PLANNING COMMISSION STAFF REPORT

Union Station Planned Development PLNSUB2012-00481 108 South 300 West September 26, 2012

PLNSUB2012-00481 Union Station

Attachment A Site Plan and Elevation Drawings

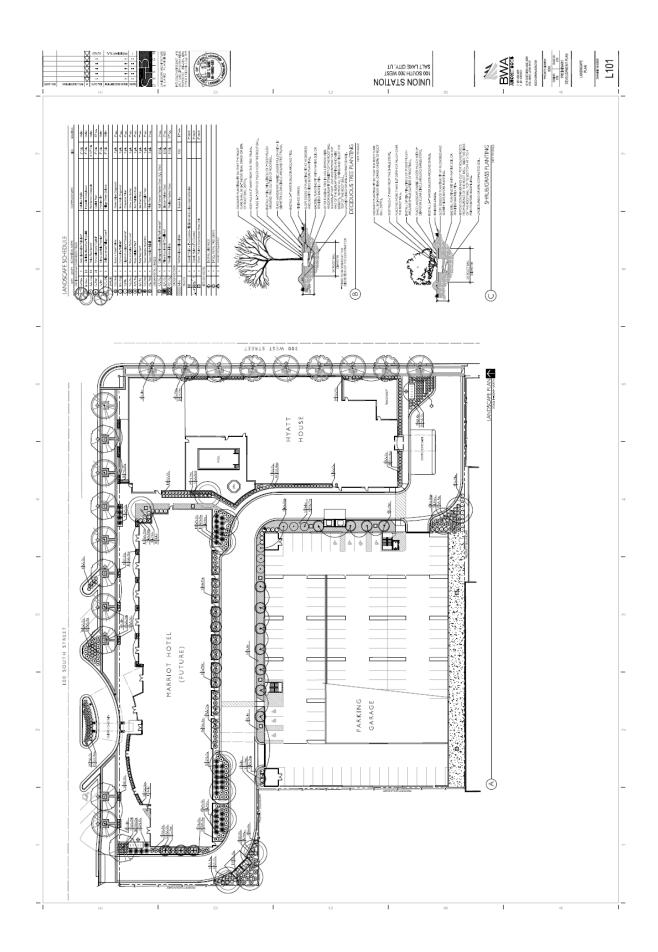
The existing lot lines for the two existing parcels do not match the proposed lot lines, shown on Sheet C1.1. If these parcels are part of a previous subdivision plat, a plat amendment is required. 2. 300 West is a State road at this location but SLC has jurisdiction for the work that is proposed behind the west curb line of 300 West. Any work proposed east of the curb line or at the sidewalk ramp at the corner of 300 West requires design approval and a permit from UDOT. 3. The developer must enter into a subdivision improvement construction agreement. This agreement requires the payment of a 5% fee (2% for the amount over \$100,000) based on the estimated cost of the public way improvements in 300 West and 100 South, not including utilities. A copy of the agreement is available in my office and can be emailed to the applicant, upon request. The developer should contact Joel Harrison (535-6234) to discuss insurance requirements for the project. This agreement must be executed after obtaining approval of the civil improvement plans (see 7. below) and, if possible, prior to obtaining a building permit. 4. The proposed combination of new street trees, pavers and concrete sidewalk shown on the preliminary plans for 300 West and 100 South is consistent with the SLC standard layout for CBD Sidewalk. The Landscape Architect should contact Bill Rutherford (Urban Forester) at 801-972-7818 to review the proposed species and staggering of street trees. A Root Watering System detail, for enhancing root growth under the sidewalk, has been provided for inclusion in the plans prepared by the Landscape Architect. Structural Soil is also needed to facilitate root growth. After the completion of this project, the Central Business District Maintenance team could take over maintenance responsibilities of the streetscape of 300 West and 100 South for the entire frontage of this project, if desired by the developer. That requires the irrigation controller and backflow preventer to be located in the public way, presumably the sidewalk, and must be on a separate meter from the other water services to the proposed

buildings. 5. The proposed drop off on the 100 South frontage of the project restricts pedestrians to a narrow passage, and requires pedestrians to walk onto private property to travel east or west along the project frontage. A revised design is recommended to provide for a better public sidewalk pedestrian corridor. 6. The proposed curb, gutter and sidewalk elevations in 100 South should be designed as much as practical to comply with APWA Std. Plan 251 (asphalt tie-in between 1% and 4%) and APWA Std. Plan 231 (sidewalk with 2% cross slope). The future Marriott Hotel is shown with multiple doors, as much as 280' apart, opening towards the 100 South right-of-way. The proposed public sidewalk must slope at approximately the same slope as the existing street across this frontage. This means that the Marriott Hotel must have multiple finish floor elevations. Design grades are needed for the TBC and sidewalk edges on both street frontages of the project, using 2% for a sidewalk cross slope. 7. A complete set of civil improvement plans and landscape plans are required for the proposed public way utilities and streetscape of 300 West and 100 South. A standard SLC Subdivision cover sheet is required at the front of the plans. The following approval signatures are required on the cover sheet: SLC Transportation SLC Fire Department SLC Public Utility Department (sewer, water & drainage improvements) SLC Engineering Division (streetscape design) SLC Planning Department (streetscape design) When the improvement plans have been finalized, a paper set must be submitted by the developer to each of these SLC divisions for signature approval. 8. A certified address is required prior to applying for a building permit.

Redline issue of 100 So proposed drop-off and angle parking. Need Admin approval, Transportation denied due to various activities and traffic demand. Parking calc 349 stalls 7 ADA &18 Bike, Required parking #s? to verify required and provided stalls etc. Note parking structure upper level ramp, parking exposed to snow & Ice shown at 5.7% - SLC standard is 4% MAX. side to side stall grade. Conflict between Arch & Civil plans with Landscape plan bldg setback on 100 So ped walk width? Minor item need ADA ramp on interior lane crossing. Show bike rack layout per SLC standard F1.f2 with 2'x6' each stall. Need st light review per Mike Berry (801-535-7147).
